SUP26-0014
617 City Park Ave.

TOLEDO - LUCAS COUNTY PLAN COMMISSIONS

TO: President Vanice S. Williams and Members of Council, City of Toledo
FROM: Toledo City Plan Commission, Lisa Cottrell, Secretary
SUBJECT: Special Use Permit for Community Recreation (Active) at 617 City Park Avenue

SITE PLAN

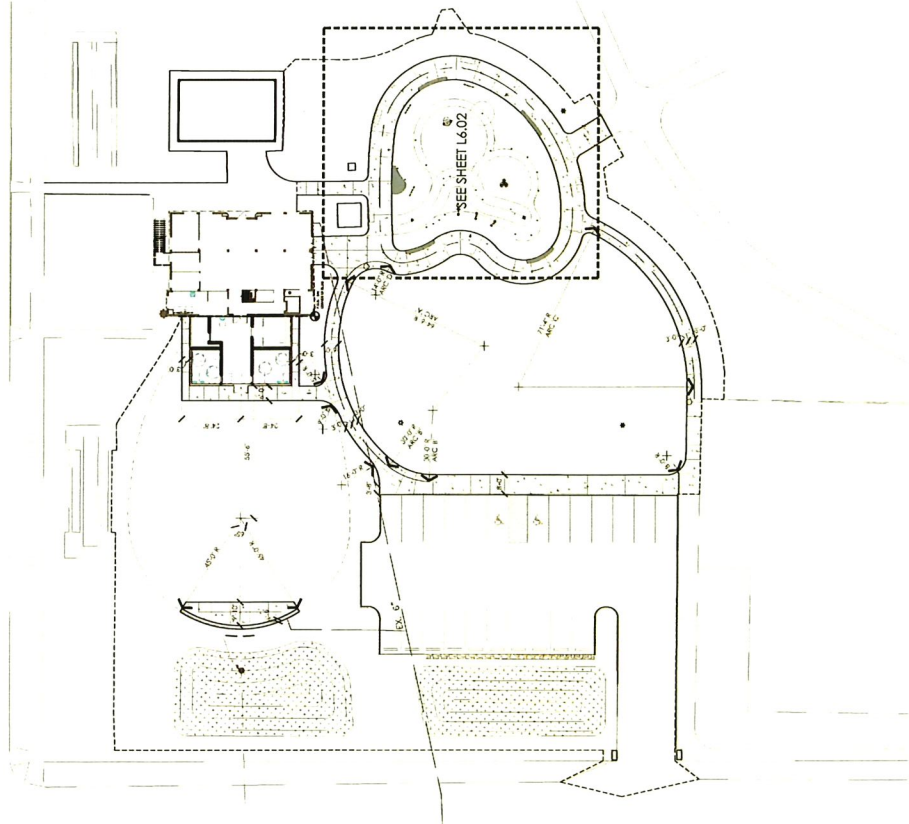
18. Per TMC§1107.1911, parking spaces laid out at a 90-degree angle shall have a width of at least nine feet (9'). **Not acceptable as depicted. A revised site plan with parking spaces nine feet (9') in width.**

19. Bicycle parking slots shall be provided pursuant to Off-Street Parking Schedule "A" (TMC§1107.0300). One bicycle parking slot shall be provided per every ten (10) parking spaces for a total of at least three (3) spots. **Not acceptable as depicted.**

- b. Perimeter landscaping must be installed along any parking lot area adjacent to a street, place, or driveway, or which is visible from an immediately adjacent property, and must include a continuous shrub row with a minimum height eighteen inches (18") to screen headlights. **Not acceptable as depicted. A revised landscape plan with a shrub row facing Elizabeth Street is required.**
